PLANT NAME: Nine Mile Point #.1

APPLICATION FOR AMENDMENT
TO
OPERATING LICENSE

Proposed Change to Technical Specifications

Nine Mile Point Unit 1 Nuclear Power Station
Rod Withdrawal Error Transient Analysis

Figure 2. NMP-1 Cycle 3 Notch Position of Transient Rod versus ΔMCPR for 8x8 Fuel

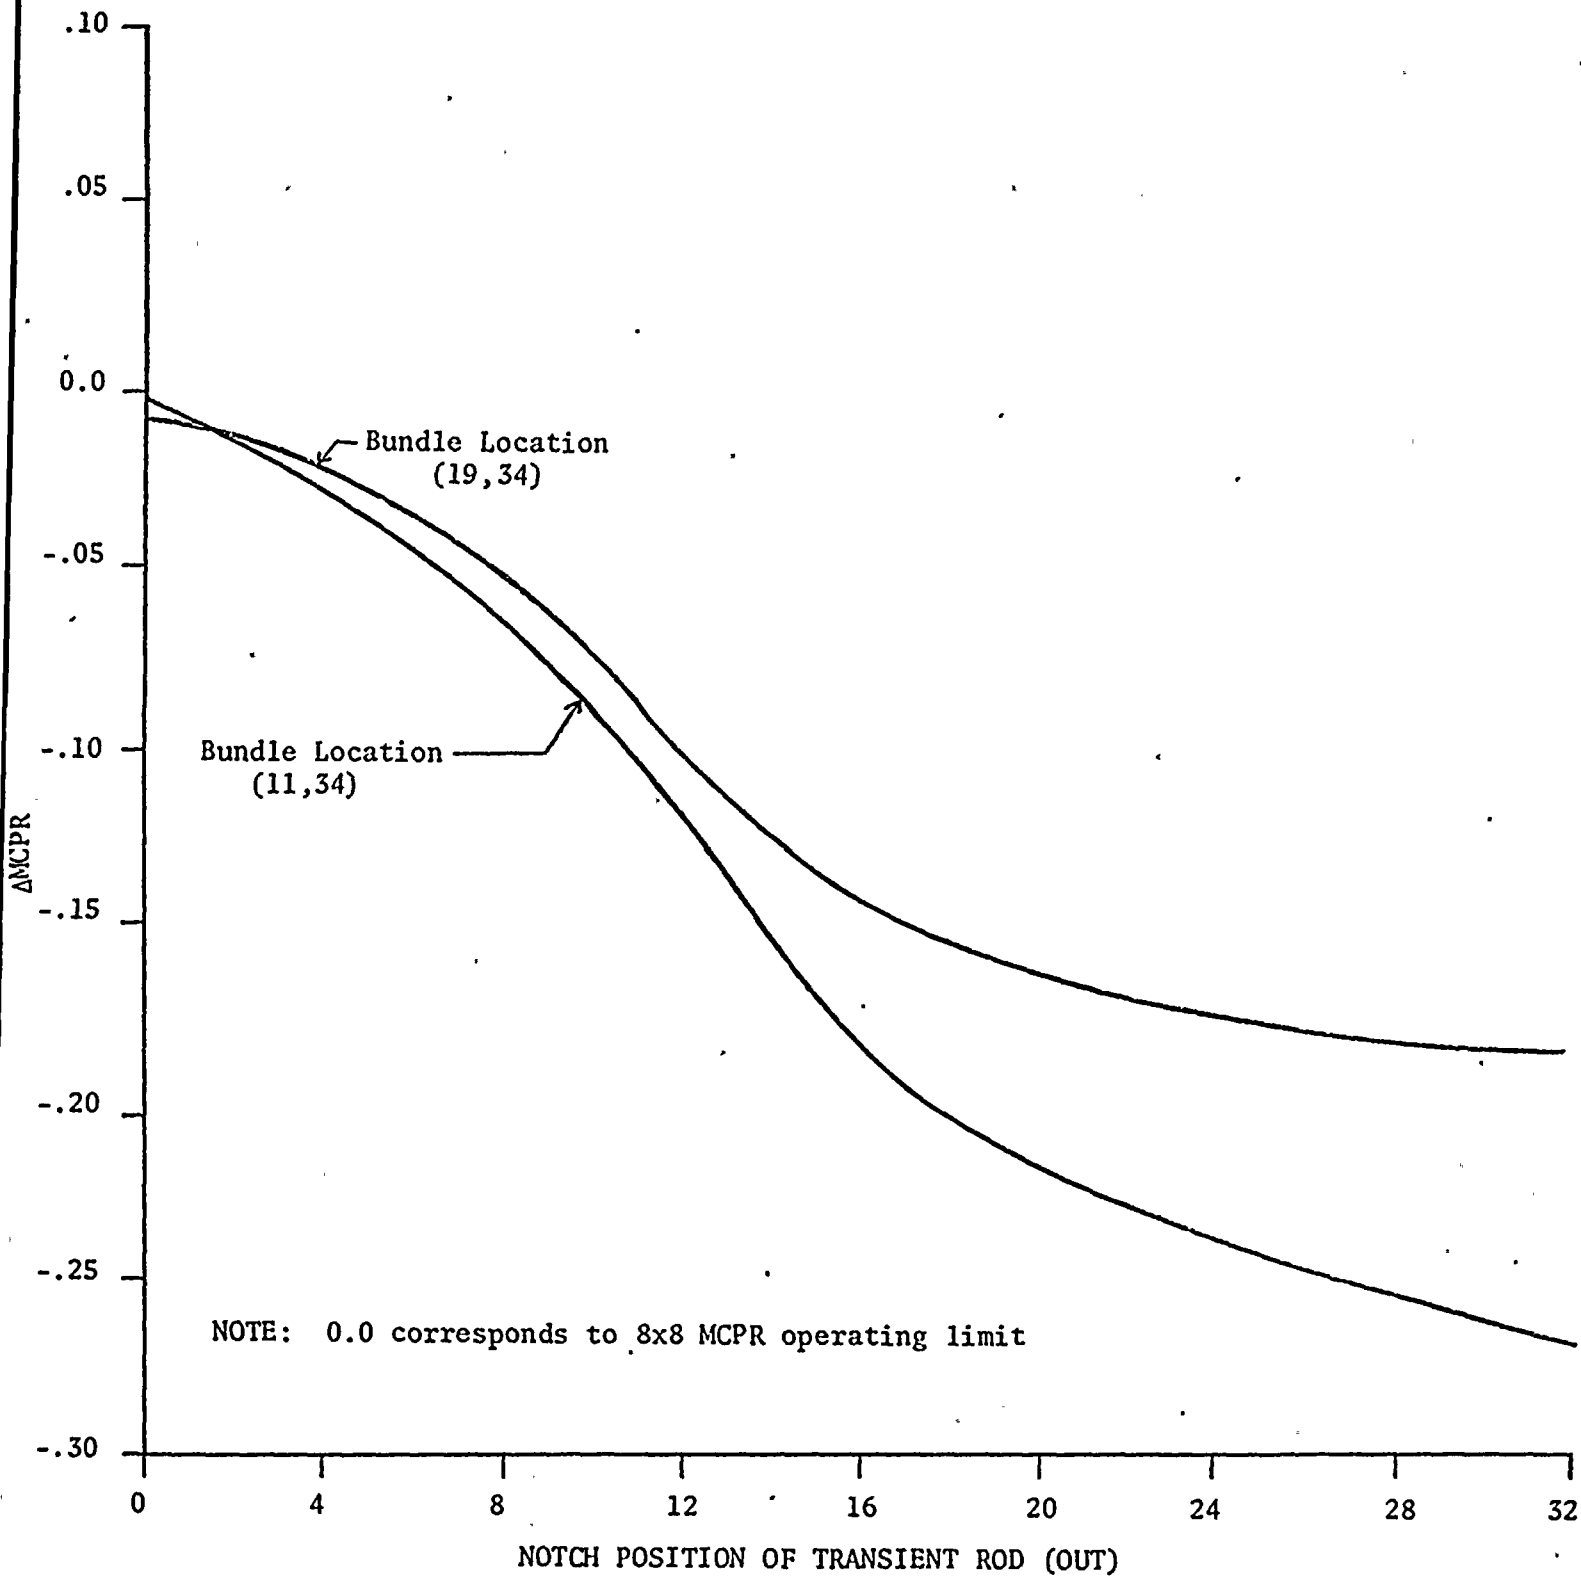
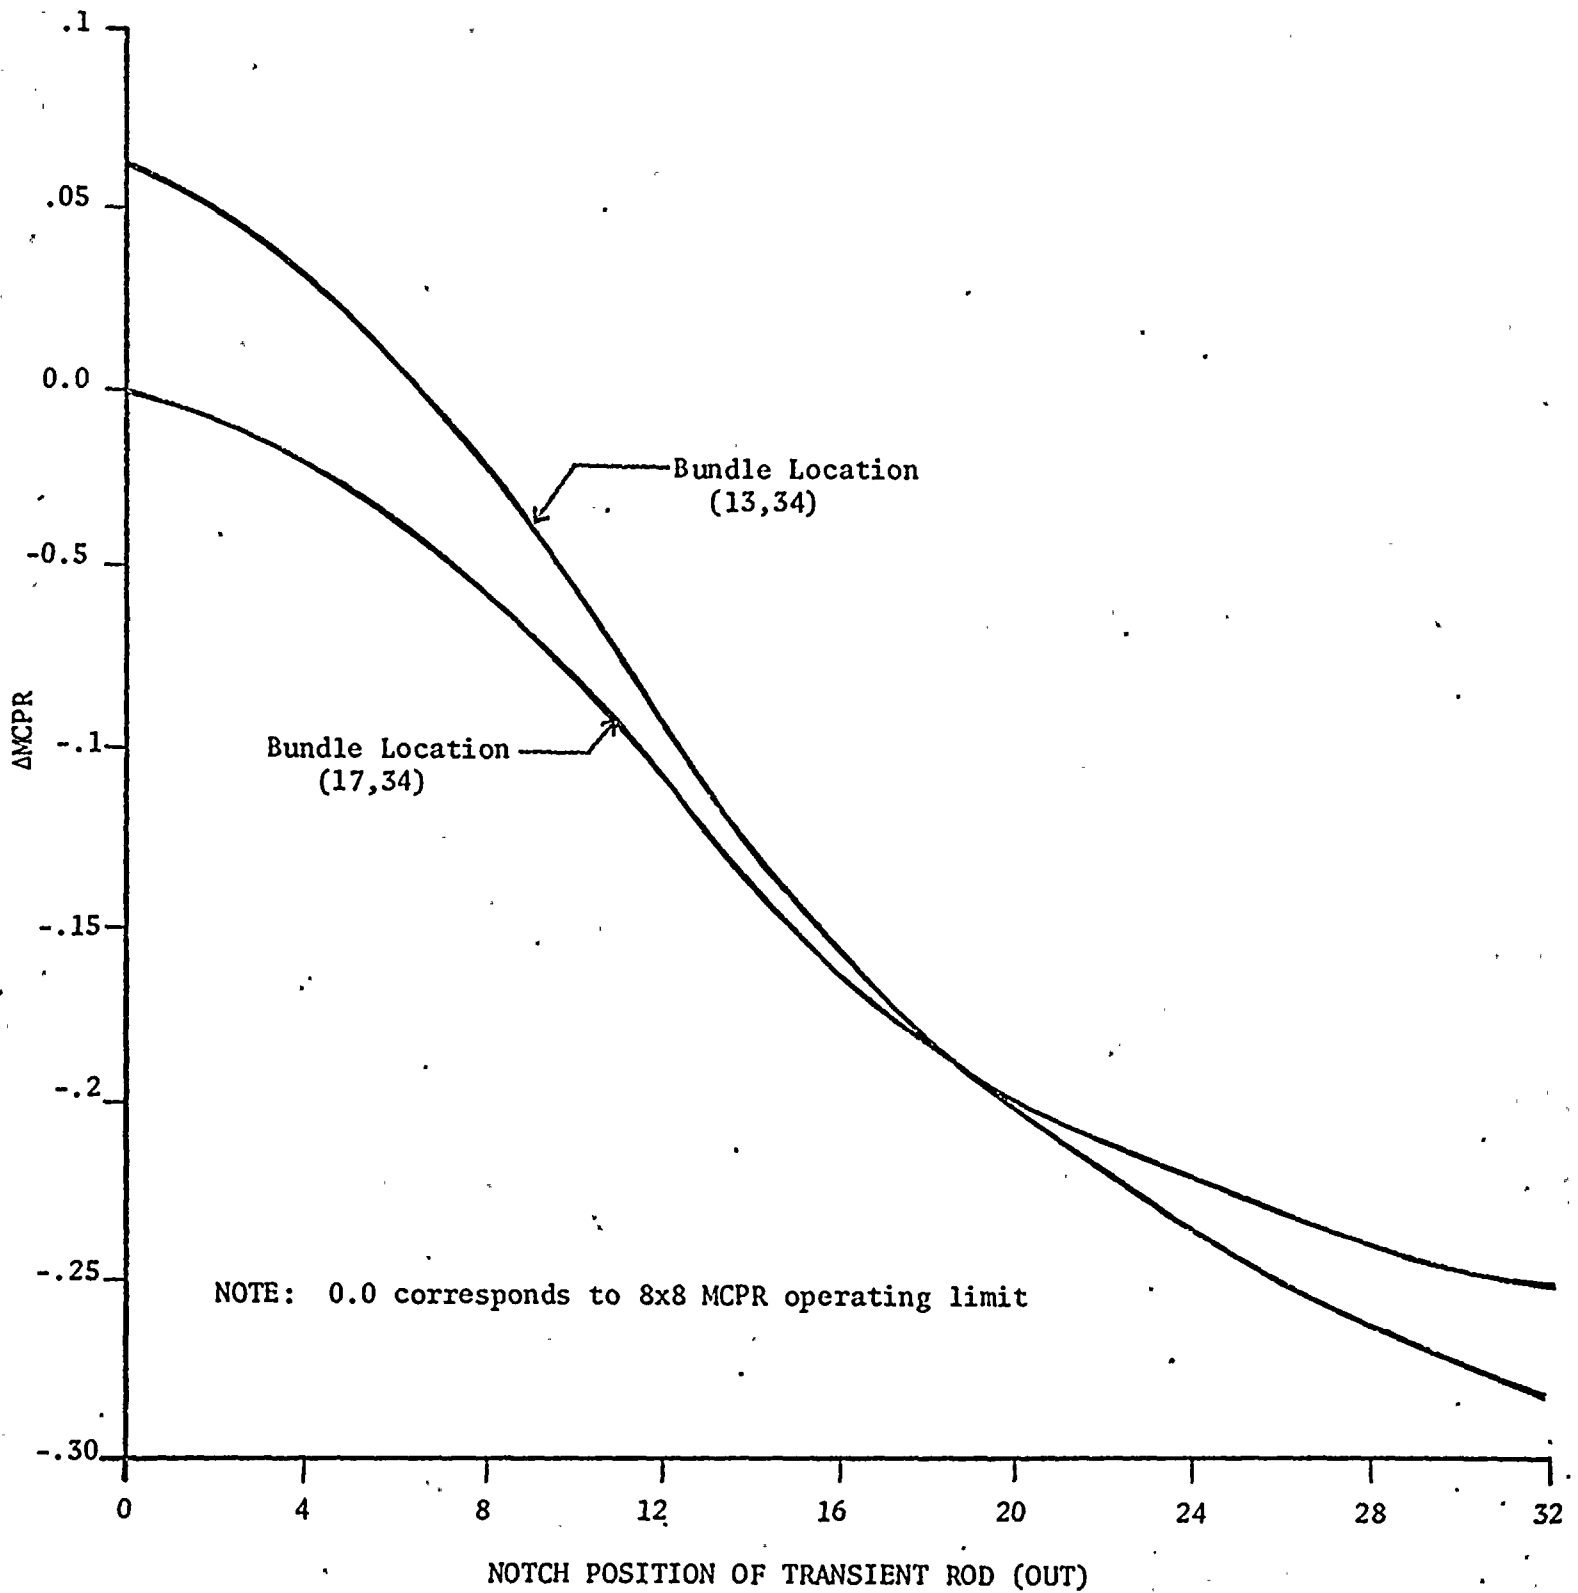
With the rod block setting at 105%, the Cycle 3 rod block response is shown in Figures 24 and 25 of Reference 4. The worst case MCPR at rod block is determined from the attached Figures 1 and 2.

As a result of this analysis, it is necessary that the 8 x 8 MCPR operating limit be increased to 1.25, in order to avoid violating the MCPR Safety Limit during a postulated rod withdrawal error transient.

<u>Item</u>	<u>Location*</u>	<u>Change</u>
Limiting Condition for Operation 3.1.7c	Page 64a	Change Minimum Critical Power Ratio (MCPR) value for 8 x 8 fuel to " <u>></u> 1.25"
